PETITION FOR ZONING VARIANCE 84-69-A

PETITION AND SITE PLAN EVALUATION COMMENTS

RE: Item No. 4 - Case No. 84-69-A
Petitioner - Joseph D. Sutherland, et ux
Variance Petition

IN RE: PETITION ZONING VARIANCE
 E/S of Northeast Avenue, 200' S of Washington Boulevard - 13th Election District
 Joseph D. Sutherland, et ux, Petitioners
 BEFORE THE
 ZONING COMMISSIONER
 OF BALTIMORE COUNTY
 Case No. 84-69-A

*Jeffrey
(Prop. Owner?)*
**PETITIONER'S
EXHIBIT 1**

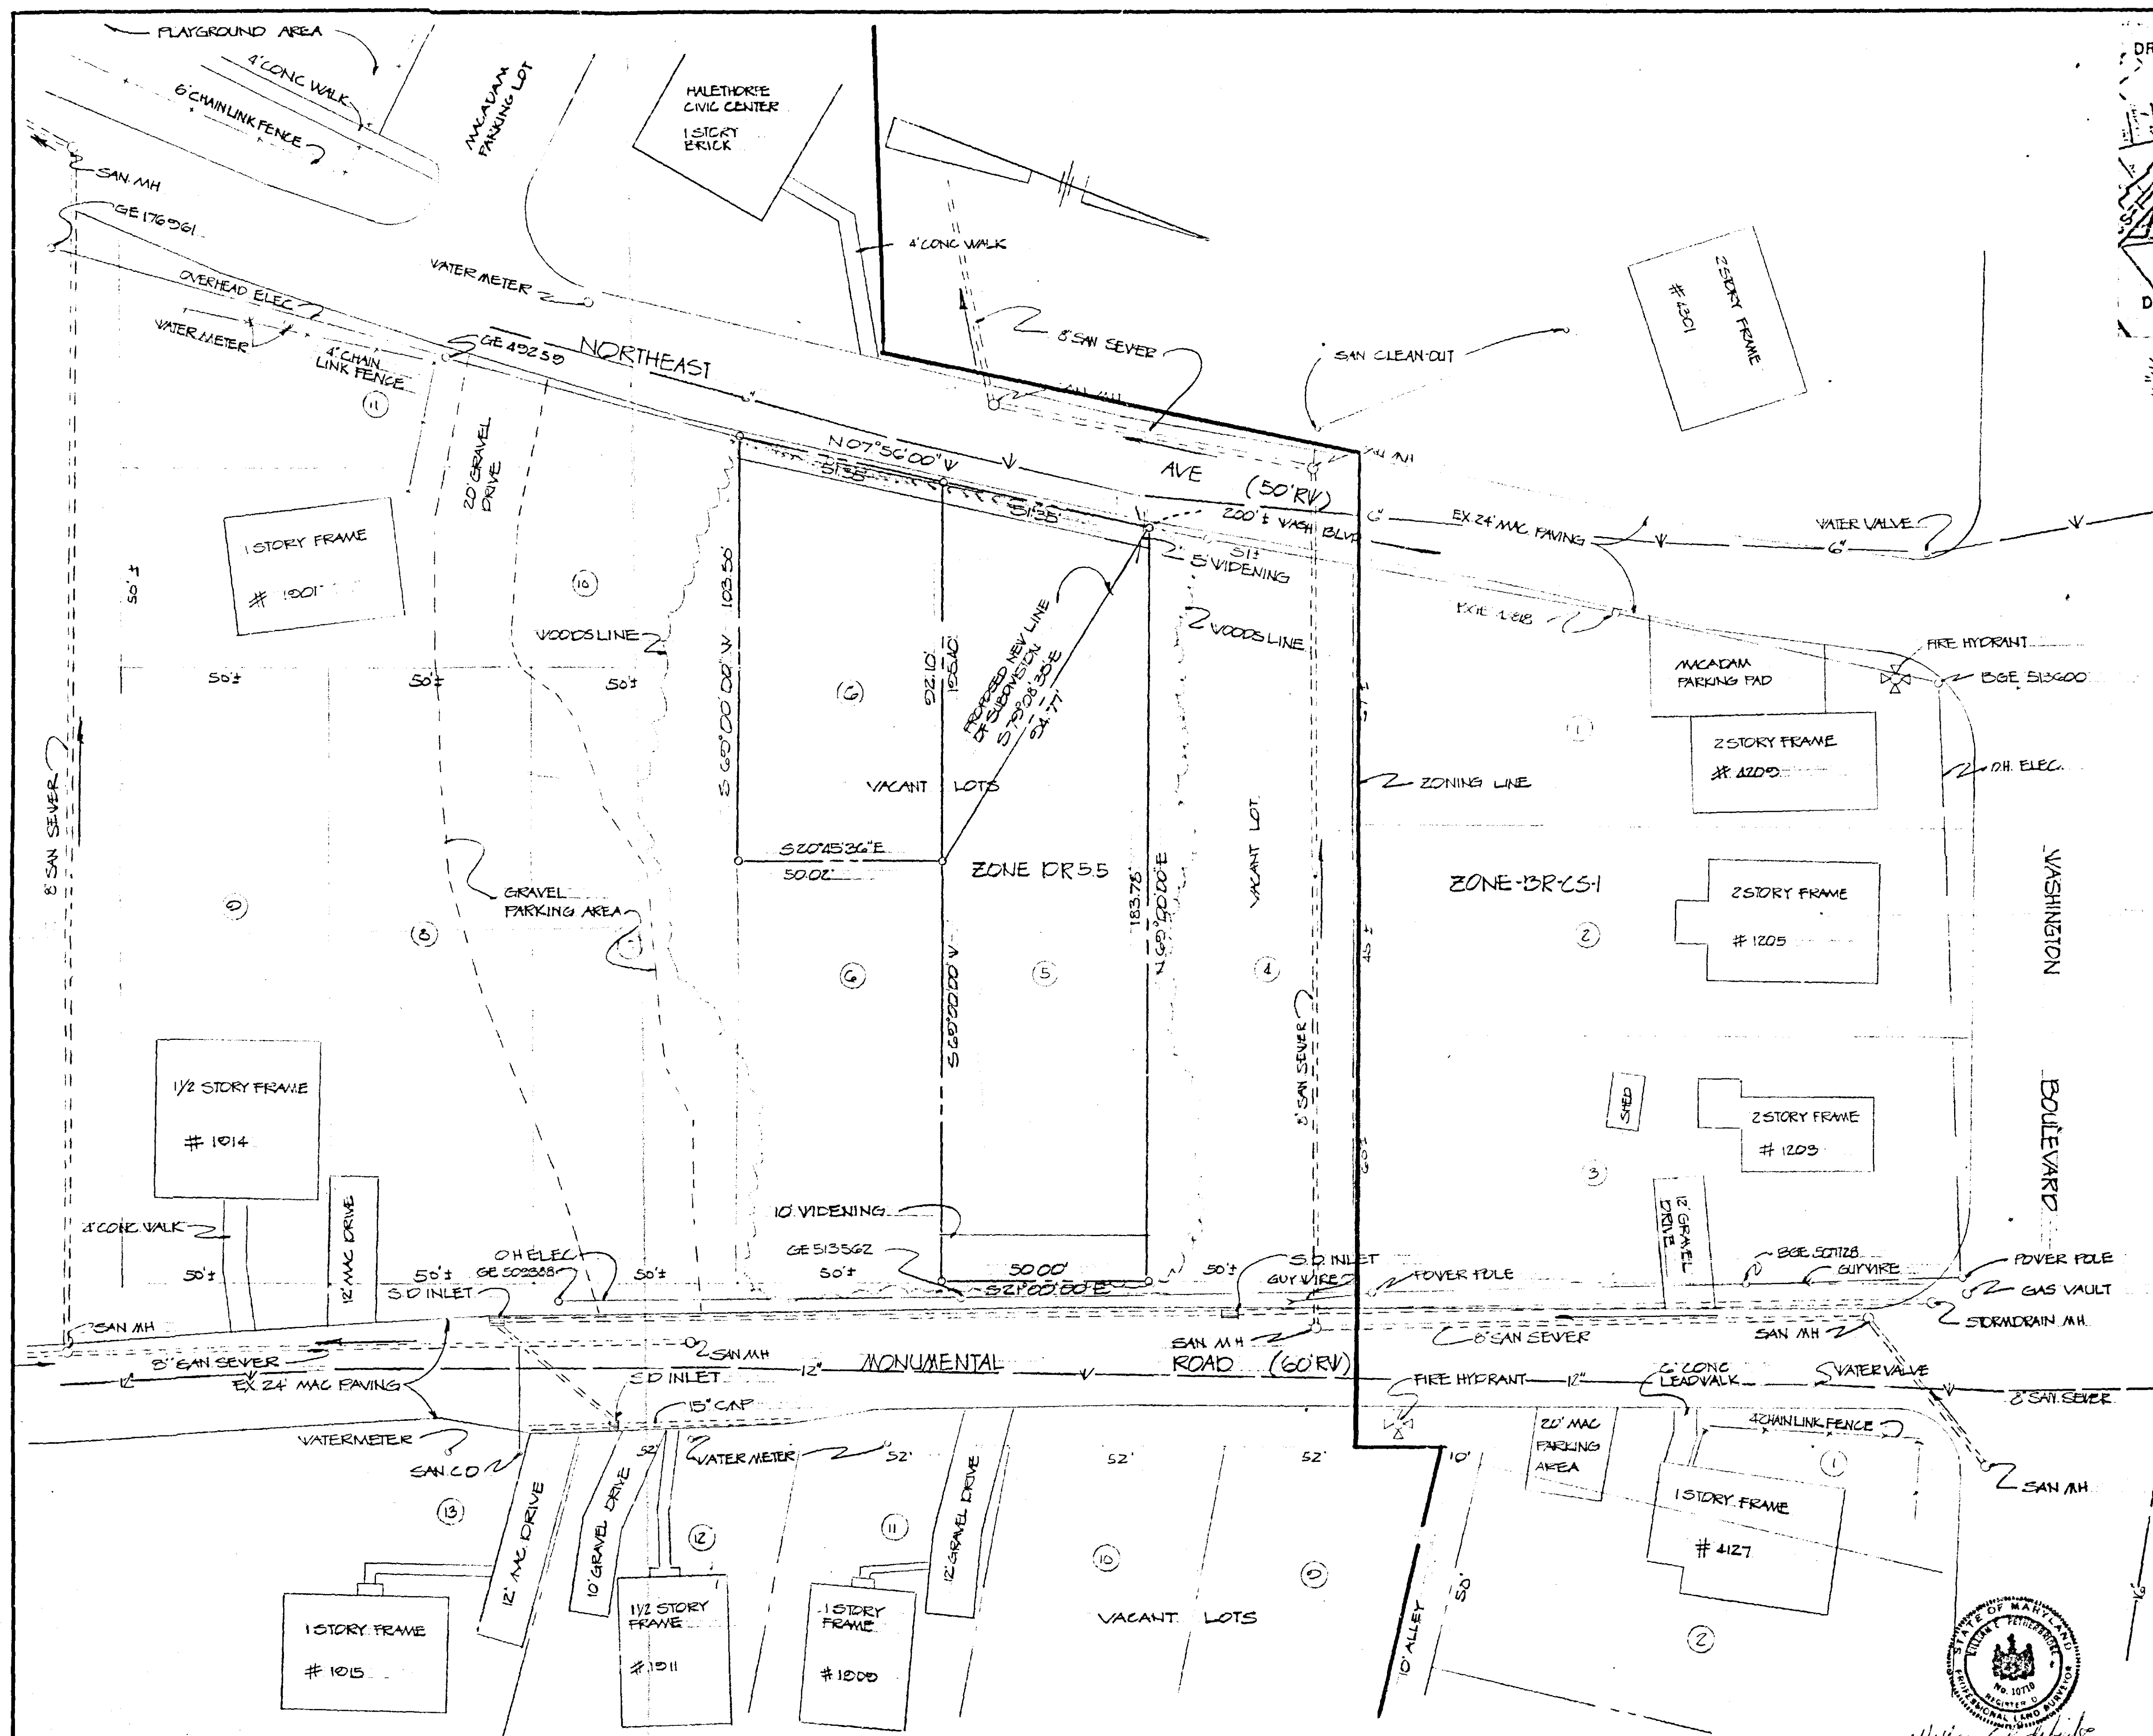
In view of your proposal to alter the configuration of lot No. 5 by transferring a portion of said lot to the adjacent property to the south which fronts on Northeast Avenue, this hearing for lot width is required.

I personally contacted Mr. Caulk and informed him that a proposed house or building area on the two properties should be shown. However, he indicated that at the time of building permit application, if the variance is granted, all zoning requirements will be satisfied.

The following comments are furnished in regard to the plat submitted to this office for review by the Zoning Advisory Committee in connection with the subject item.

Monumental and Northeast Avenues, existing public roads, are proposed to be further improved in the future as 40 and 30-foot closed section roadways on 60 and 50-foot rights-of-way, respectively.

Development of this property through stripping, grading and stabilization could result in a sediment pollution problem, damaging private and public holdings downstream of the property. A grading permit is, therefore, necessary for all grading, including the stripping of top soil.

The Petitioner must provide necessary drainage facilities (temporary or permanent) to prevent creating any nuisances or damages to adjacent properties, especially by the concentration of surface waters. Correction of any problem which may result, due to improper grading or improper installation of drainage facilities, would be the full responsibility of the Developer.

There are 6 and 12-inch public water mains in Northeast and Monumental Avenues, respectively. There is 8-inch public sanitary sewerage in each of these roads.
